Property: §§ Chatham Road, London SW11 §§§

Scott Schedule

REF: 160620-4

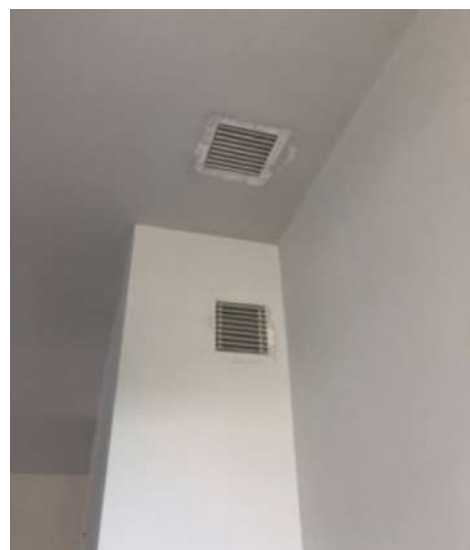
Basement WC Fan – to be relocated

How will the circular to plastic rectangular connection be made professionally? Suggest circular duct taken through the utility room into the Equipment Store as TSA Report c/w fire damper and silencers.

REF: 300620-7

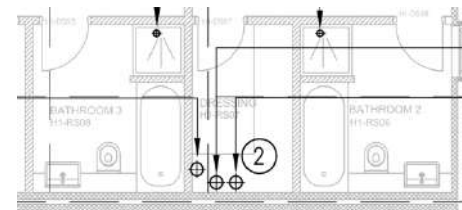
The fan doesn't really fit as is too high protruding into the space.

Re-use of existing fan: Airflow rates will need to be measured to ensure Part F Building Regs flow rates are achieved
